NS9750B-A1

Errata

*90000738, Rev F*

NS9750B-A1 Hardware  
Reference, Rev. B

**Example:**

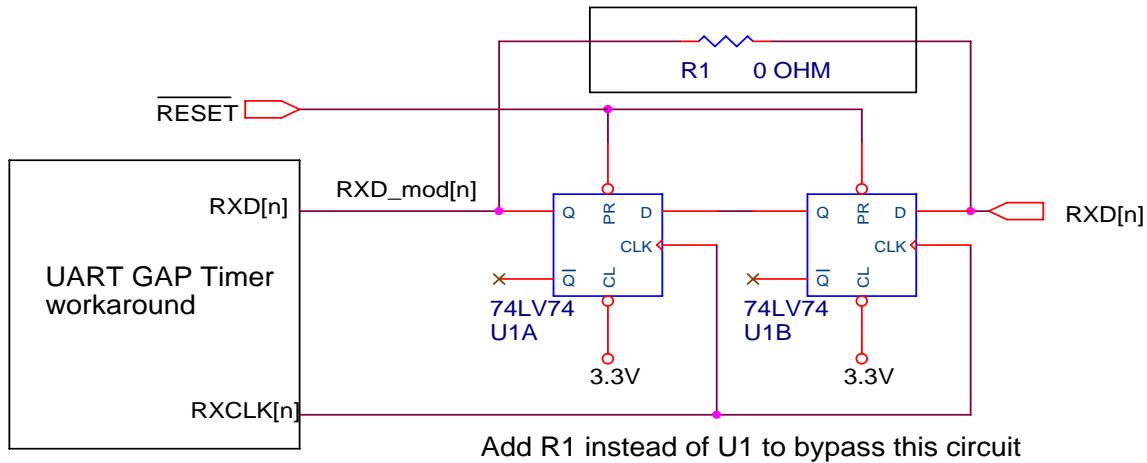
## SPI slave data output high impedance control

There is a problem that occurs in slave mode when there are other slaves on the SPI bus. When the slave select signal is de-asserted, the data output pin fails to go into a high impedance state and interferes with any other slave that is trying to drive the data signal.

**Workaround:** Do this for each SPI port. Externally buffer the data\_out signal with a tri-state buffer and connect the select signal to the active low tri-state control pin. There should be a pullup resistor on the output of the buffer to prevent floating when no slaves are selected.

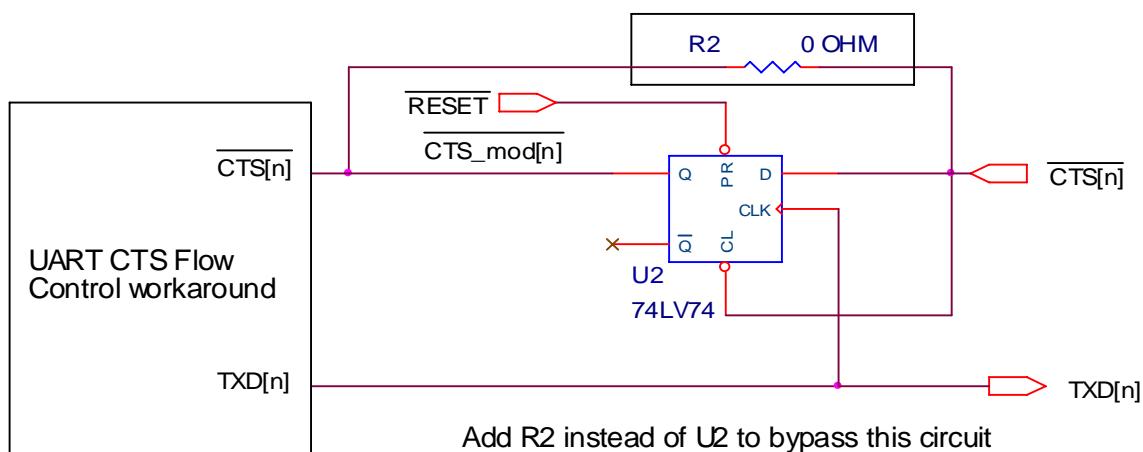
## UART gap timer

The start bit of a new character may not be detected when the character or buffer gap timer expires. Framing, parity, or data corruption occur when a start bit is missed.

**Hardware workaround:**

**Note:** The hardware workaround requires that you have installed the appropriate software patch found in the NETOS SW Toolkit (on the Web).

A hardware workaround eliminates the possibility of receiving a start bit when a character or buffer gap timer is expiring. The workaround drives the baud clock off-chip and synchronizes the incoming data with this clock. As a result, the buffer and character gap timers and the next start bit have a fixed and known relationship with each other.

## Limitations:

- The TMODE bit in the Bit-rate register must be cleared.
  - Baud rates are limited to those available in x16 mode
  - Baud rates with a divisor of 0 are not possible for all CPU frequencies. This translates to a maximum baud rate of 460k in x16 mode.
  - Baud rates with a divisor of 1 are not possible for CPU frequencies below 147MHz. This translates to a baud rate of 230k in x16 mode.
  - The buffer and character gaps must be an even multiple of the sample clock period. For a 9600bps UART in x16 UART mode, the equation is:
  - Timer increment =  $((1/9600) / 16) \times 2 = 13.020\text{us}$
  - One GPIO per UART is required to output the baud clock. The baud clock can be output on the RI pin on each UART. This function is controlled by the RXEXT bit (27) in each Serial Bit-rate register.

If multiple UARTs are running at the same baud rate, one baud clock can be used for the multiple UARTs.

This figure shows a recommended logic workaround:

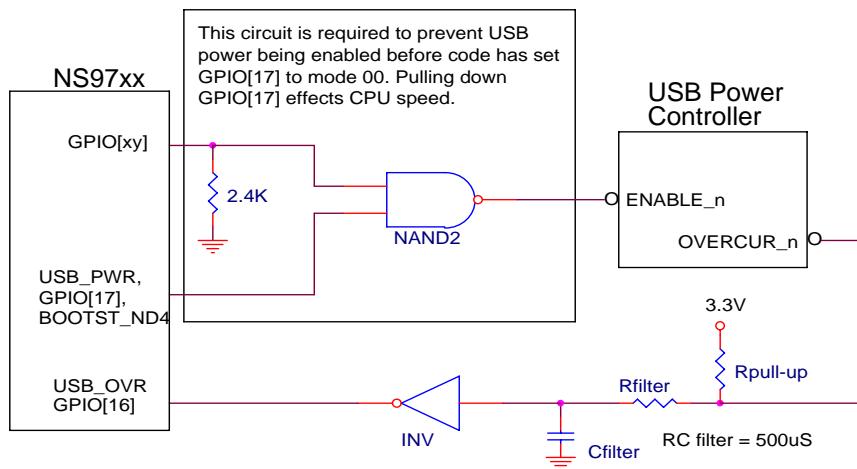
## USB OVR and USB PWR

The USB OVR (over current) input on gpio[16] is not shown in the GPIO MUX pinout tables. The polarity of this signal cannot be changed. It is true high, normally requiring an external inverter and noise filter to prevent false indications of over current.

The USB PWR (power) control output requires additional external logic and GPIO to prevent USB power from being enabled from the time power is valid until the code has set the USB registers and selected gpio[17] to mode 00. The polarity of USB PWR is true high. Pulling down GPIO[17] to disable the USB power control changes the CPU bus speed because this pin is also bootstrap – ND4.

Updates are required to the BSP to change gpio[16] from mode 00 to mode 02. Timer 11 is disabled, allowing USB OVR to be recognized by the USP IP. Even though Timer 11 is disabled, the Timer clock select field must be set to 111-External pulse event to set GPIO[16] to an input.

If you are using USB Host, GPIO[16] must be reserved for the USB OVR function.

Designs that add the additional GPIO to prevent USB power-on during startup would require the BSP, as a final step, to set this GPIO to output a 1.
